**TOWN OF BAY HARBOR ISLANDS
MORRIS N. BROAD COMMUNITY CENTER
1175 95TH STREET
BAY HARBOR ISLANDS, FL 33154**

DESIGN REVIEW BOARD

**May 7, 2024
7:00 PM**

FINAL AGENDA

1 (01) - 1ST FLOOR -EXISTING/ DEMOLITION PLAN-DRB-1

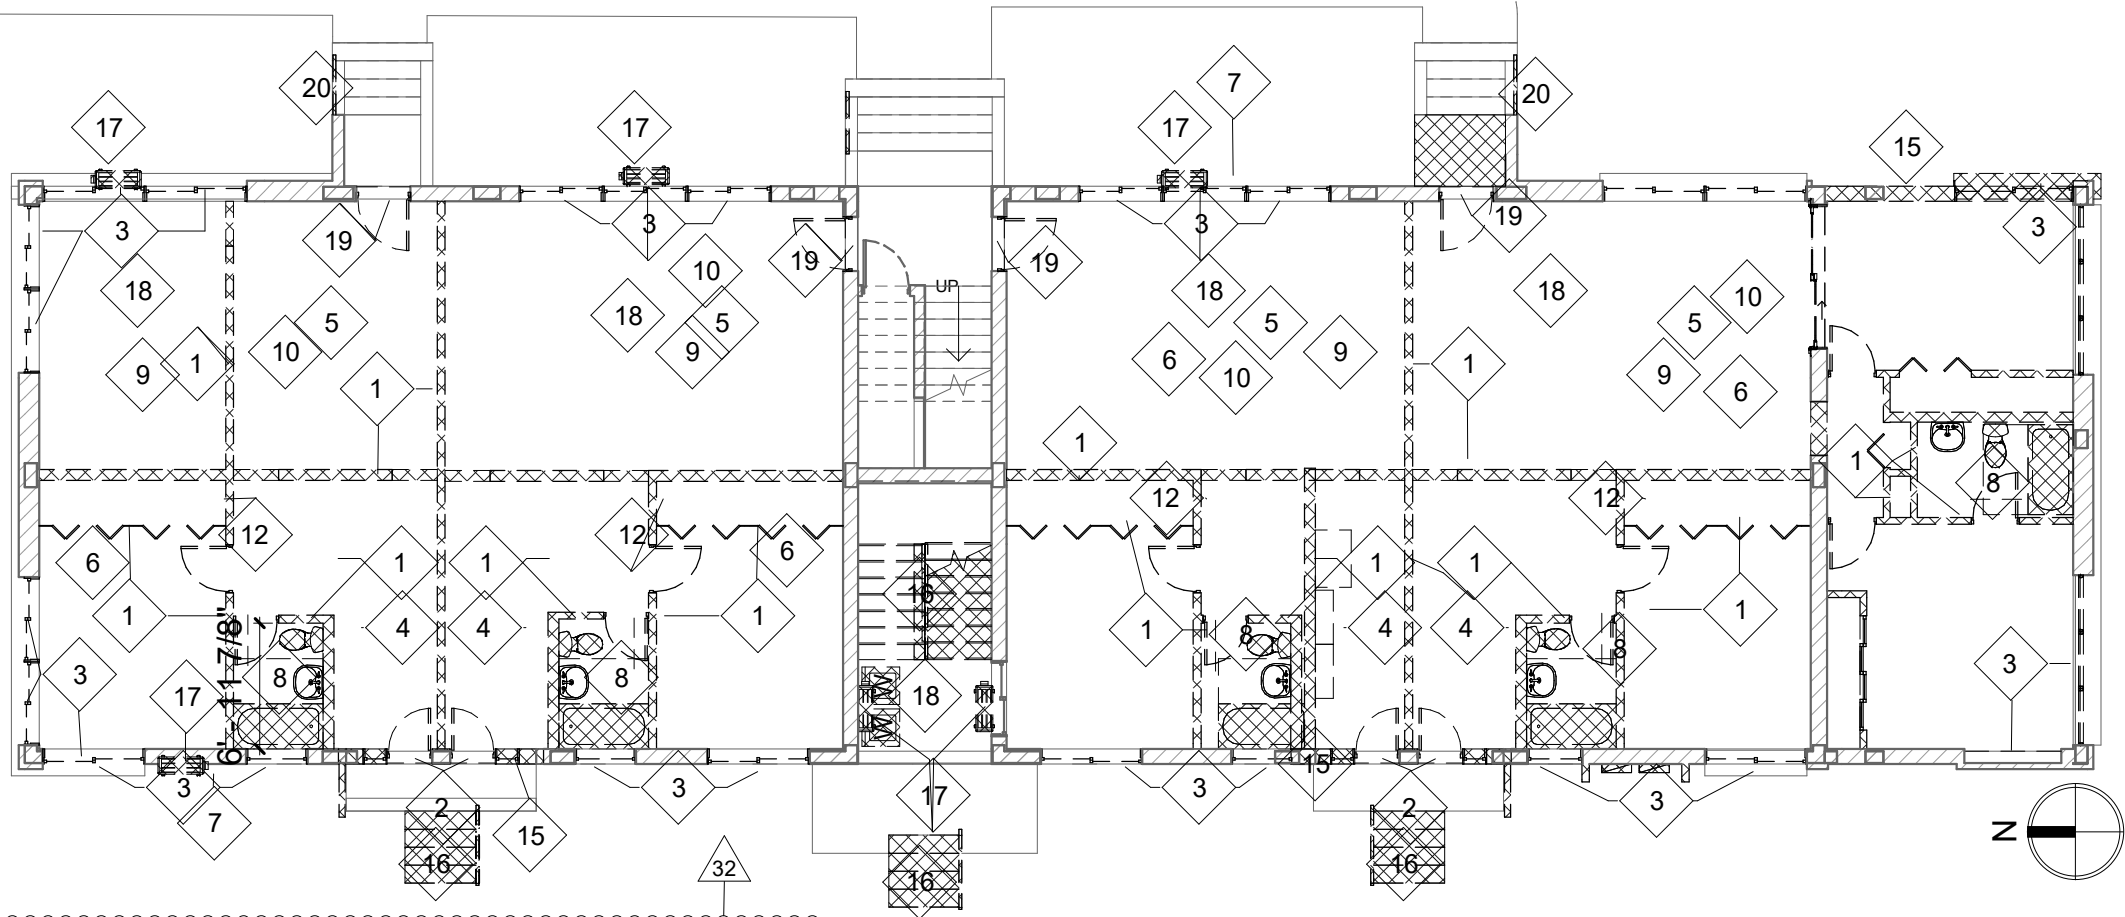
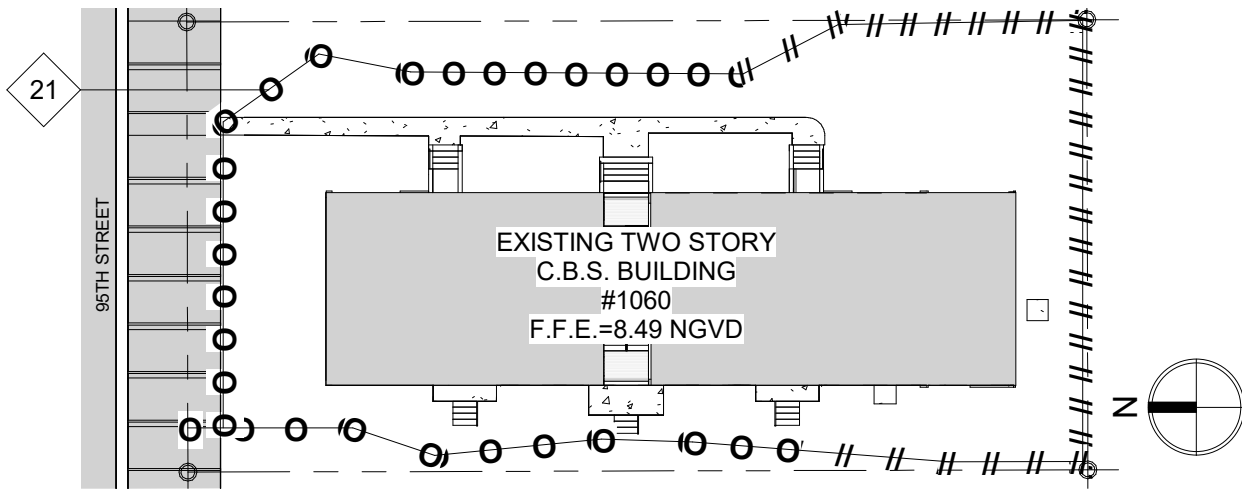
1. PLANS APPEAR TO INDICATE THAT ADDITIONS ARE BEING PROPOSED. PLEASE PROVIDE AND EXISTING AND PROPOSED PLAN.
7.What is the purpose of the temporary fence? Is this simply to secure the site at present?

1 (02) - 2ND FLOOR -EXISTING/ DEMOLITION PLAN-DRB-1
DRB.5.1 Scale: 1" = 10'-0"

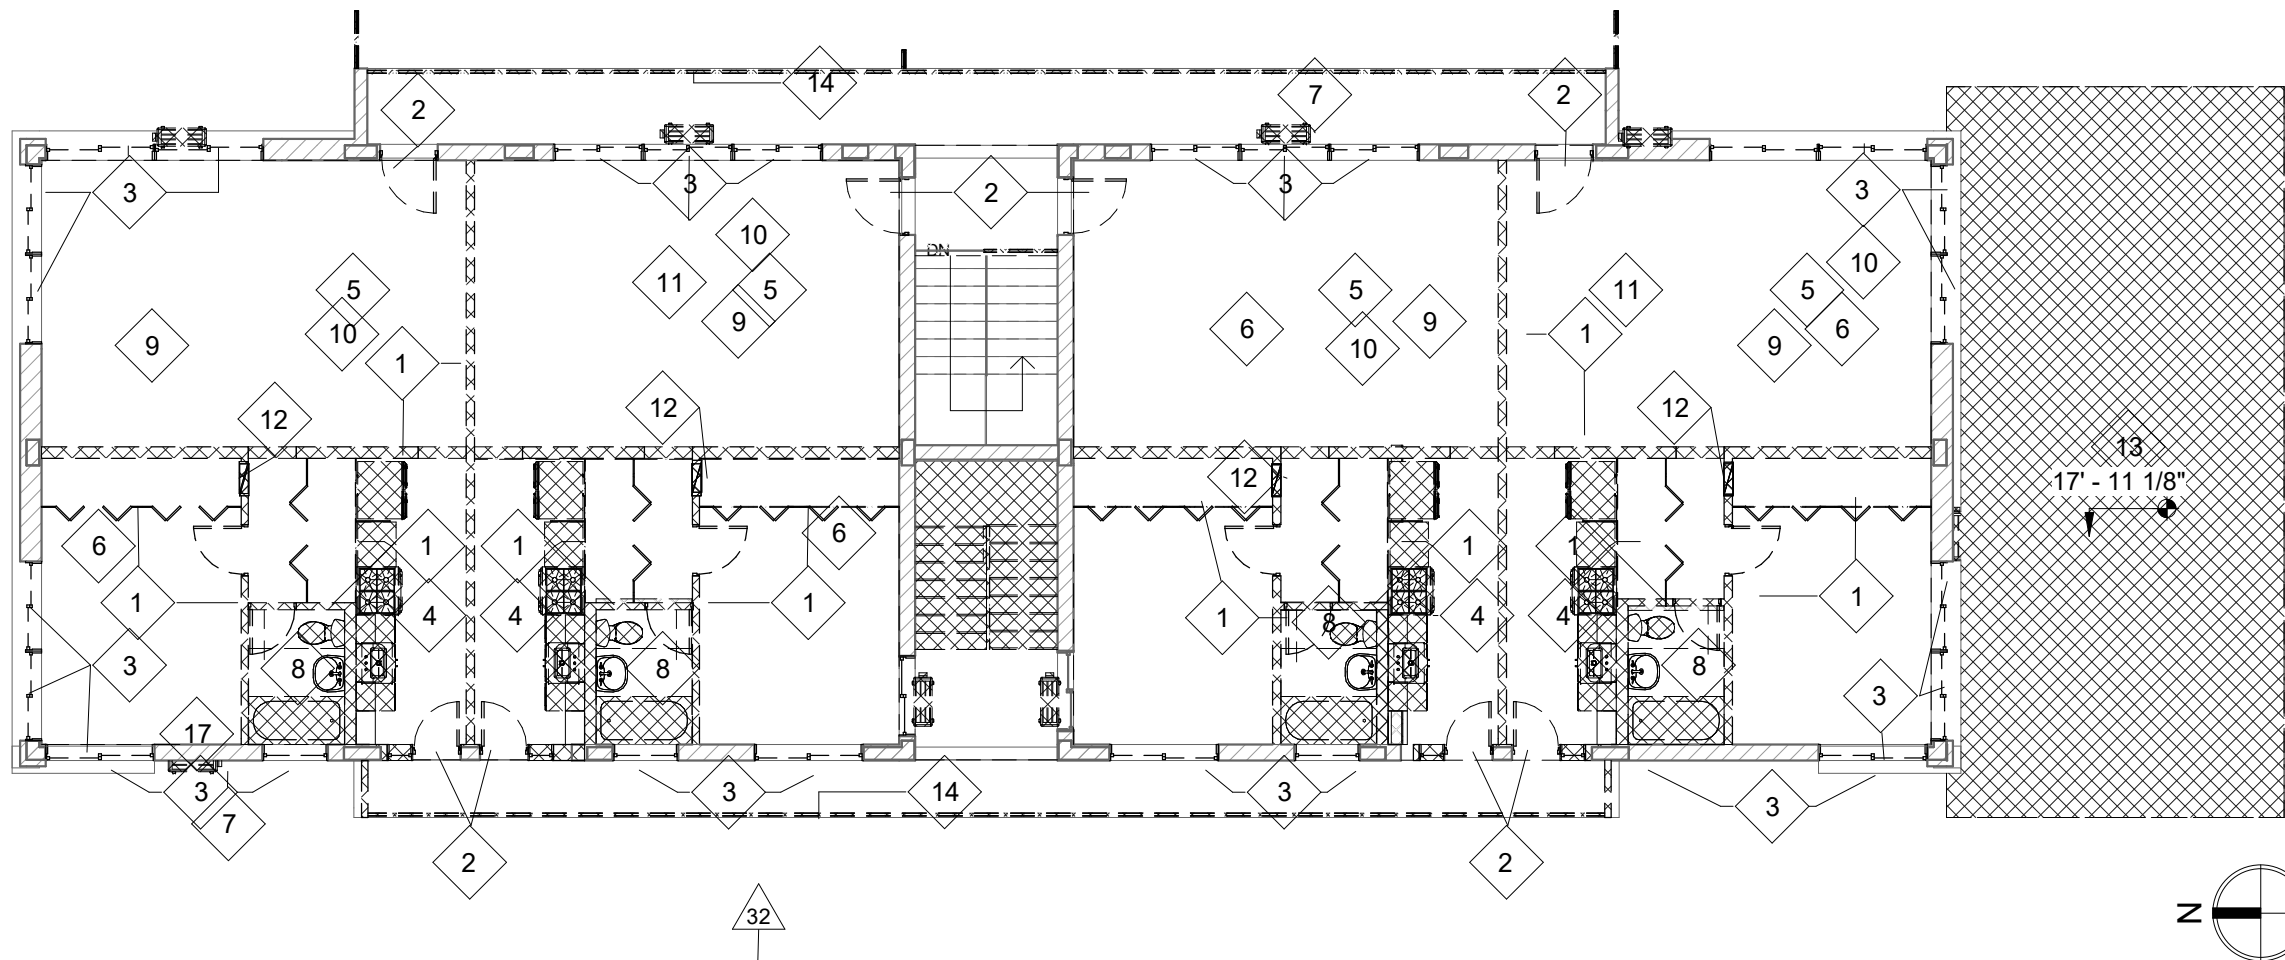
Revision Number 32 1. PLANS APPEAR TO INDICATE THAT ADDITIONS ARE BEING PROPOSED. PLEASE PROVIDE AND EXISTING AND PROPOSED PLAN.

TYP. FLOOR PLANS

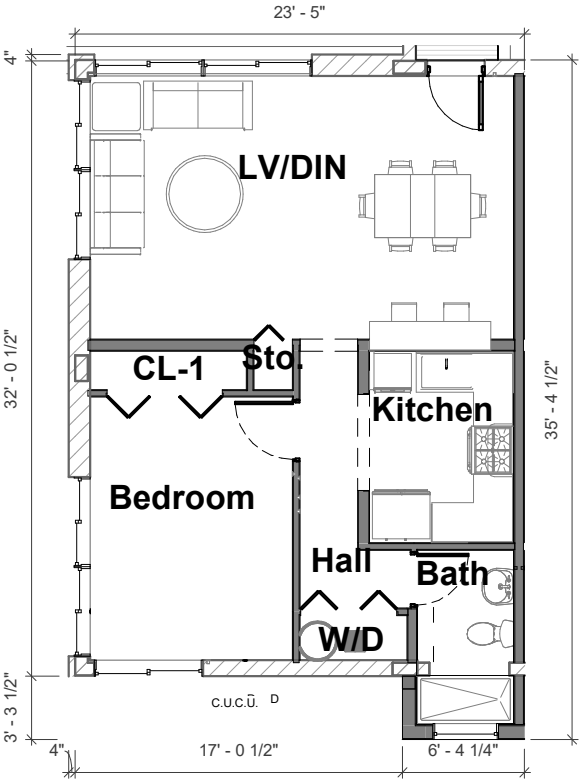
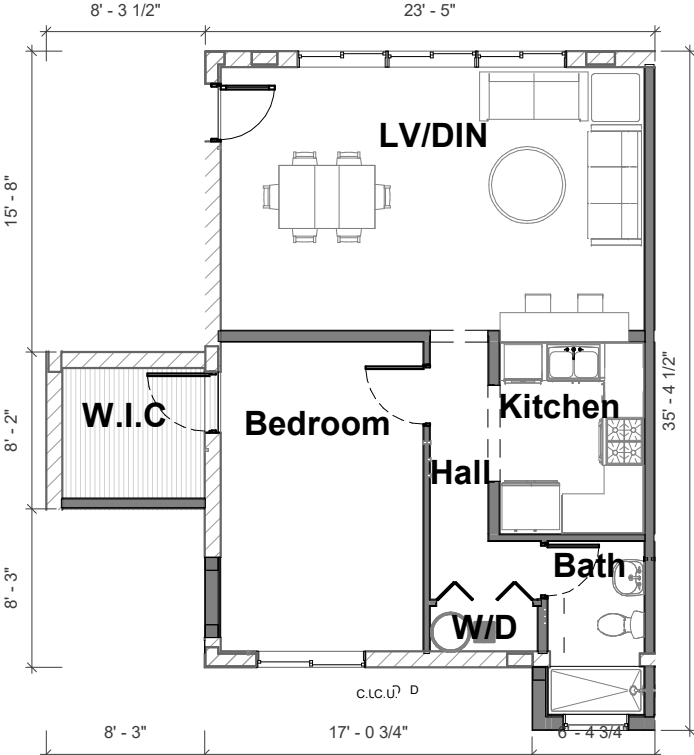
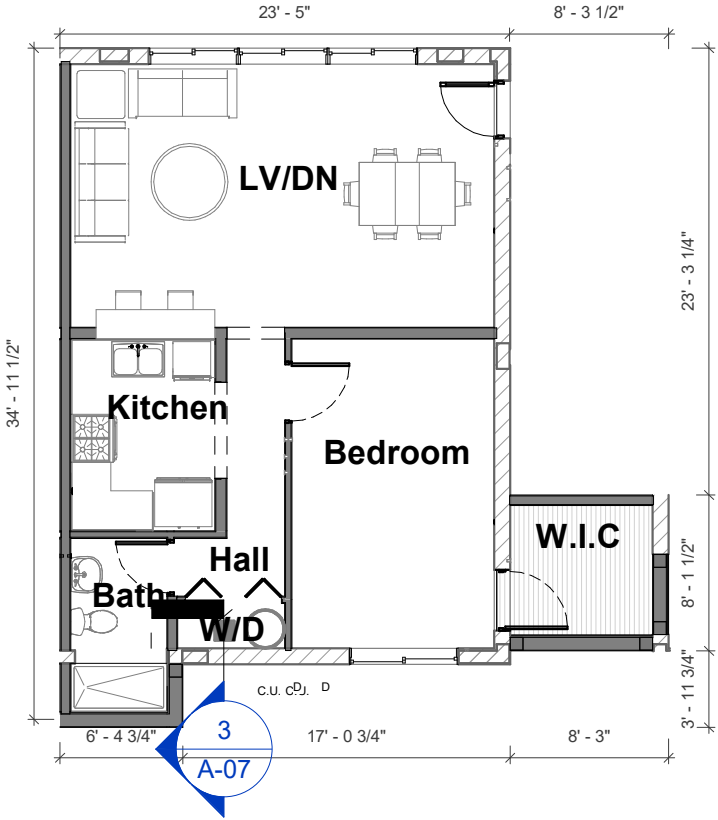
Revision Number	Revision
51	B.Provide a table listing each DU noting the number of bedrooms / bathrooms / square footage/

TYP FLOOR PLANS-B

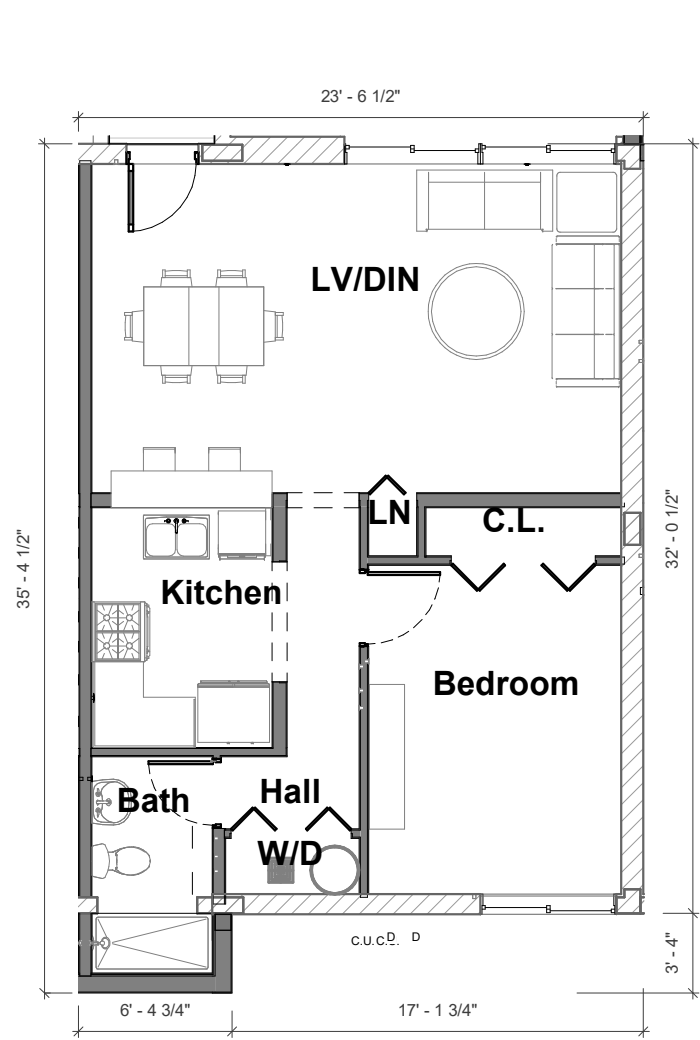
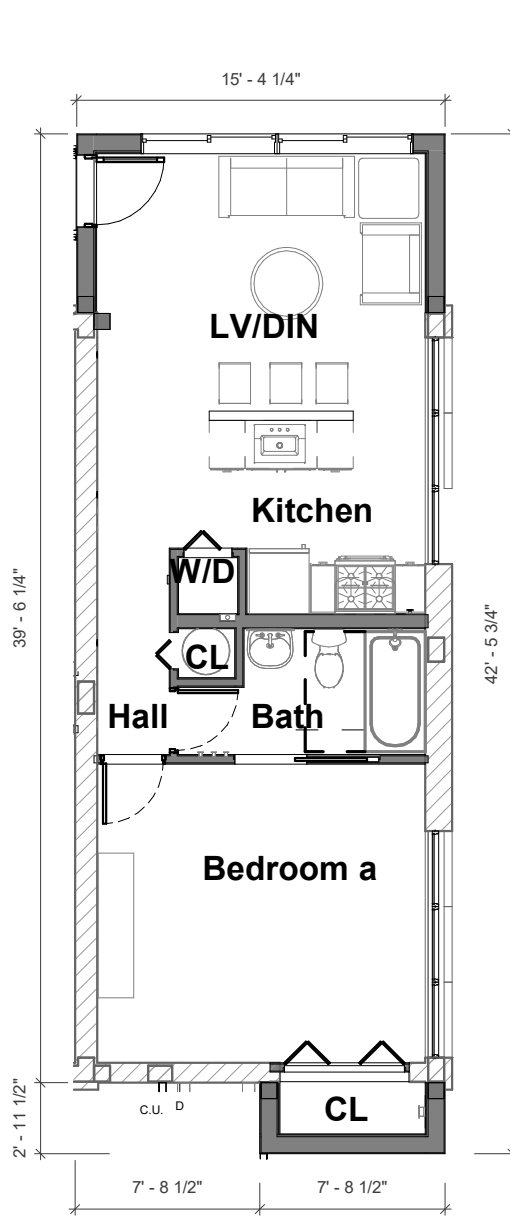
Revision Number	Revision
51	B.Provide a table listing each DU noting the number of bedrooms / bathrooms / square footage/

1 Wall section - Proposed addition - DRB
DRB.6.2 Scale: 1/2" = 1'-0"

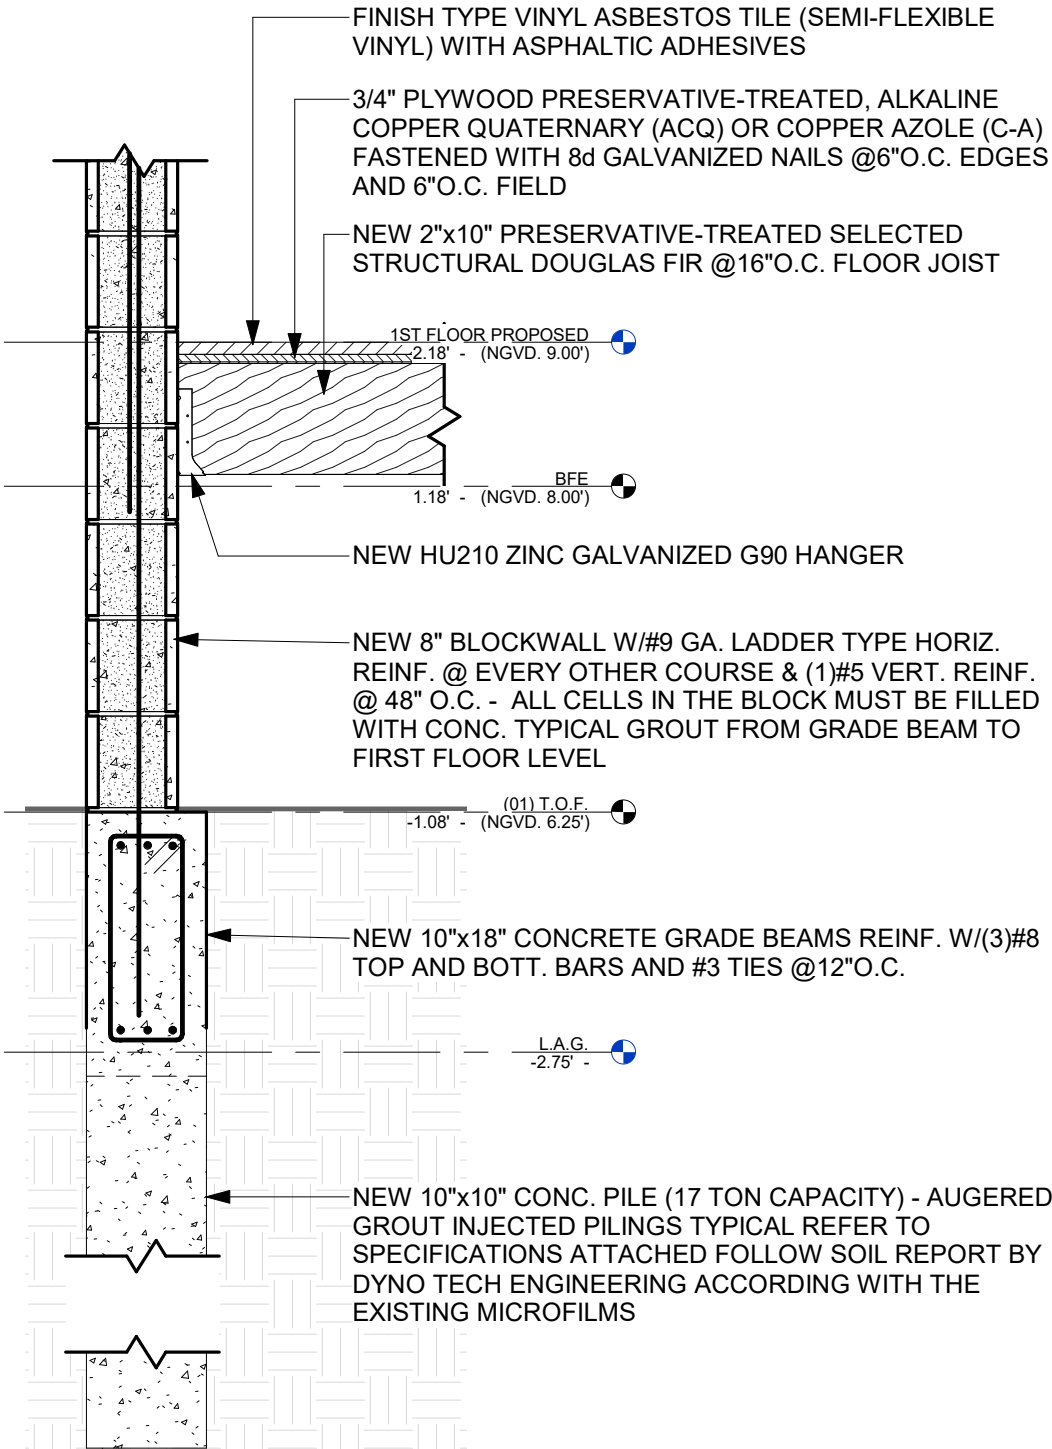
Revision Number 55 5. Provide details on proposed 115 Square foot addition covered area.

EAST ELEVATION

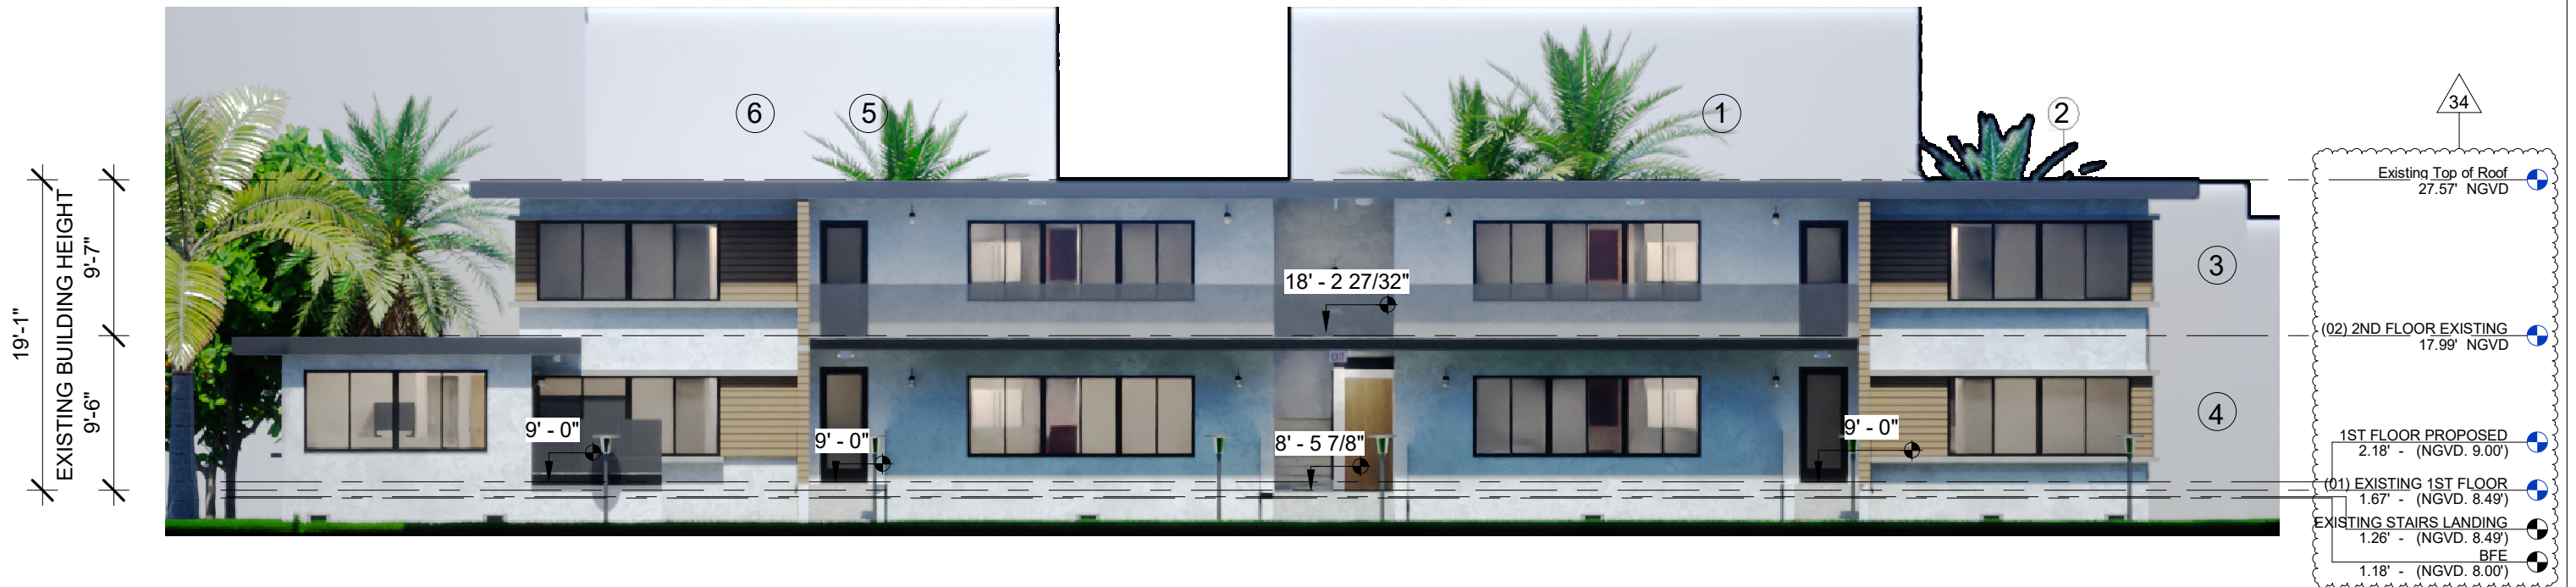
3. SHOW ALL PROPOSED ELEVATIONS (INCLUDING FINISHED FLOOR AND EQUIPMENT SERVICING THE BUILDING, GARAGE FFE, ETC). SHALL COMPLY WITH THE REQUIREMENTS IN ASCE 24,FEMA AND FBC. -ADDITIONAL COMMENTS MAY BE PENDING AFTER REVIEW OF THE REQUESTED DOCUMENTS AS LISTED ABOVE.
10. While pictures have been provided the code normally requires colored building elevations for all 4 sides of the building. Since there are minimal exterior changes perhaps a better representation would suffice due to the expense of renderings.
